# UNITED STATES PATENT AND TRADEMARK OFFICE

APPLICATION NO.	FILING DATE	FIRST NAMED INVENTOR	ATTORNEY DOCKET NO.	CONFIRMATION NO.
10/705,384	11/10/2003	Pierre Liu	2011133	4323

**Office Action Summary**

FIG. 3'

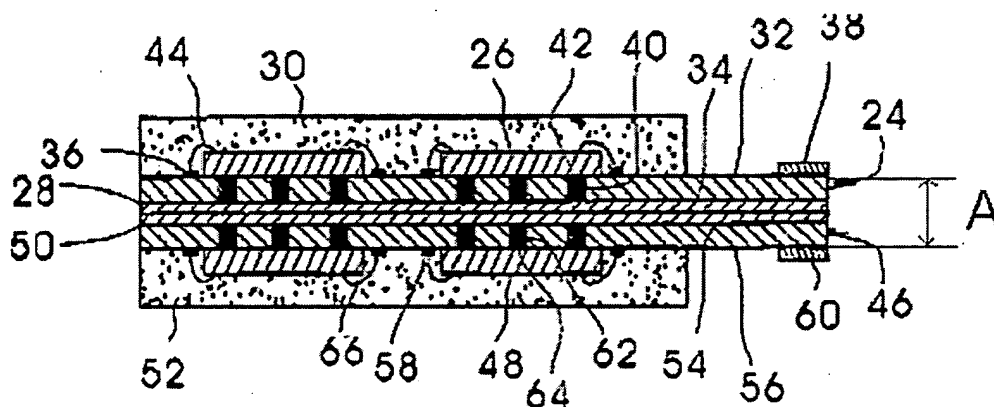
Regarding claim 1, Hsieh discloses a small memory card (fig. 3), comprising:  
 a multilayer substrate A (fig. 3' modified by the examiner for examination purposes, the multilayer substrate A comprising layers 24, 28, 50 and 46) having an upper surface 32 (fig. 3) and a lower surface 56 (fig. 3), the upper surface formed with a plurality of connected points 36 (fig. 3) and a plurality of golden fingers 38 (fig. 3) electrically connected to the plurality of connected points 36 (column 2, lines 47 – 53),

the substrate A (fig. 3') arranged in the electric device, so that the plurality of golden fingers 38 may be electrically connected to the electric device (column 2, lines 62 – 65);

at least one memory chip 26 (fig. 3), which is arranged on the upper surface 32 of the substrate A electrically connected to a plurality of connected points 36 on the upper surface 32 (column 2, lines 55 – 58); and

a glue layer 30 encapsulated the memory chip 26 (column 2, line 62).

Hsieh fails to teach the glue layer 30 is a transparent glue used to protect the memory chip and display the mark of the memory chip or the substrate.

Regarding claim 2, Hsieh discloses the lower surface 56 (fig. 3) of the substrate A (fig. 3') arranged a memory chip 48 (fig. 3) and the glue layer 52 (fig. 3) is encapsulated the memory chip 48.

Regarding claim 3, Hsieh and Chen shows the upper surface 32 of the multilayer substrate A (fig. 3') is arranged two memory chips 26 (fig. 3), and the transparent glue layer is encapsulated the two memory chips at the same time.

Regarding claim 4, Hsieh shows the memory chip 26 is electrically connected to the connected points 36 of the upper surface of the multilayer substrate A by wires 44 (fig. 3; column 2, lines 57 and 58).
